RE: Willow Pass Generating Station  
Application for Certification 08-AFC-6

APPLICATION FOR CERTIFICATION  
FOR THE **WILLOW PASS**  
**GENERATING STATION**

Docket No. 08-AFC-6

**Figure 67-1**  
**NERC/WECC Voltage Performance Parameters**

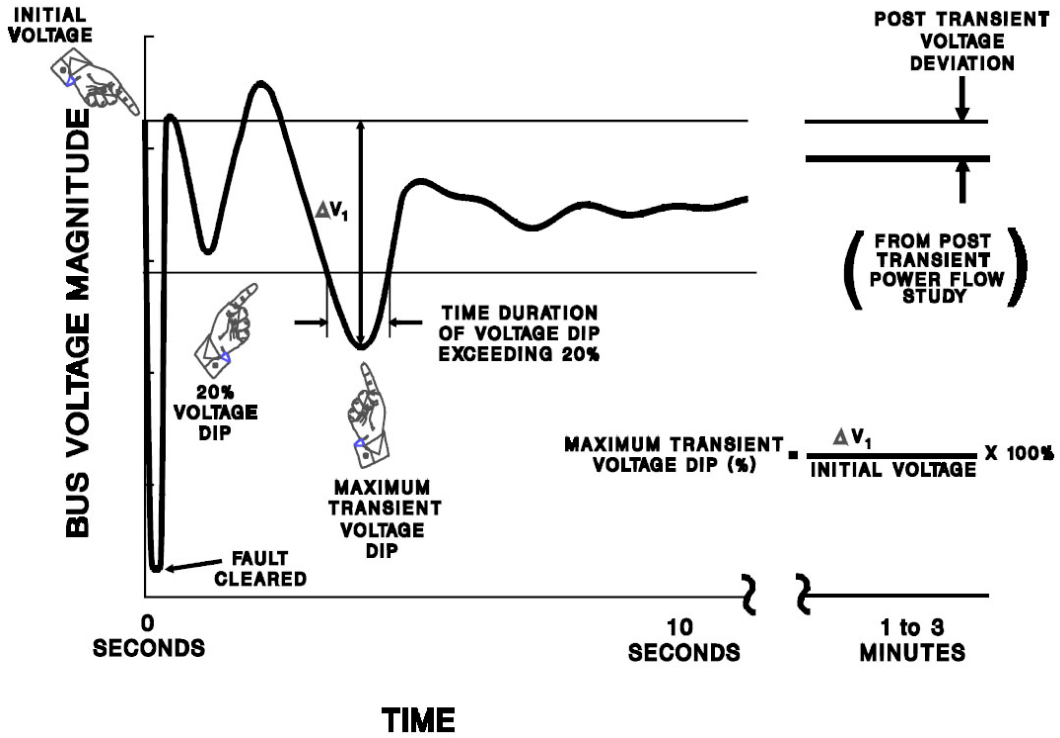
**67. For each analysis performed (power flow overloading and voltage criteria, short circuit, reactive power deficiency, post-transient voltage analysis), identify the reliability planning criteria used to determine reliable criteria violations.**

Table 67-1 and Figure 67-1 are excerpted from the WECC System Performance Criteria and comprise the transient stability criteria used in the analysis for WPGS.

**FIGURE 7**  
**SITE GRADING AND DRAINAGE PLAN**  
 DRAINAGE, EROSION, AND SEDIMENTATION CONTROL PLAN  
 FOR THE WILLOW PASS GENERATING STATION PROJECT

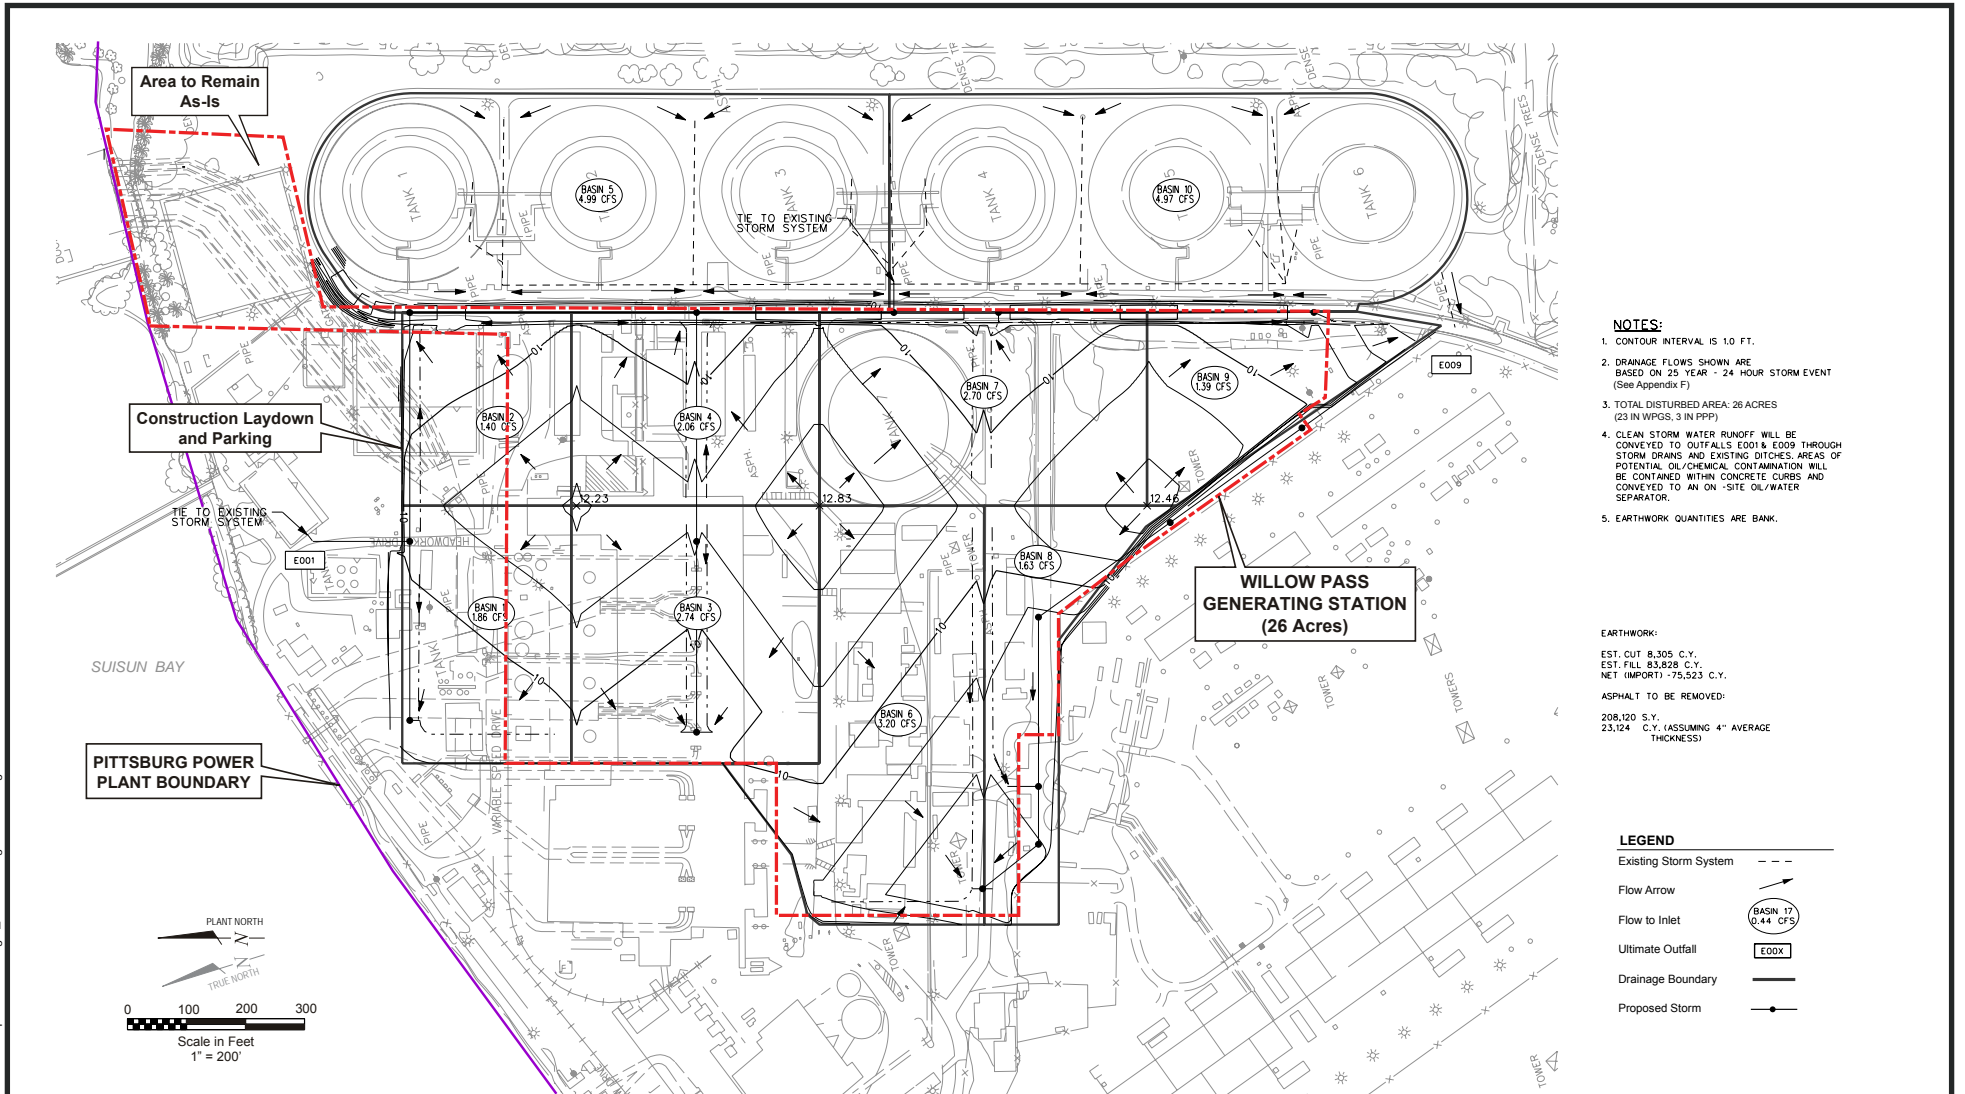
- D. Drainage Map – The draft DESCP shall provide a topographic site map(s) at a minimum scale 1" = 100' showing existing, interim and proposed drainage systems and drainage area boundaries. On the map(s), spot elevations are required where relatively flat conditions exist. The spot elevations and contours shall be extended from the project site a minimum distance of 100 feet in flat terrain.**

- F. Clearing and Grading Plans – The draft DESC shall provide a delineation of the proposed recycled water and brine return pipeline indicating all areas to be cleared of vegetation and areas to be preserved. The draft DESC shall provide elevations, slopes, locations, and extent of all proposed grading as shown by contours, cross sections or other means. The locations of all soil stockpile areas, fills, or other special features will also be shown. Illustrate existing and proposed topography tying in proposed contours with existing topography.**

Figure 7 shows the site grading plan for the WPGS site. Plans depicting specific details of soil excavation and grading associated with the water supply and discharge pipelines will be developed as project design is advanced prior to construction.
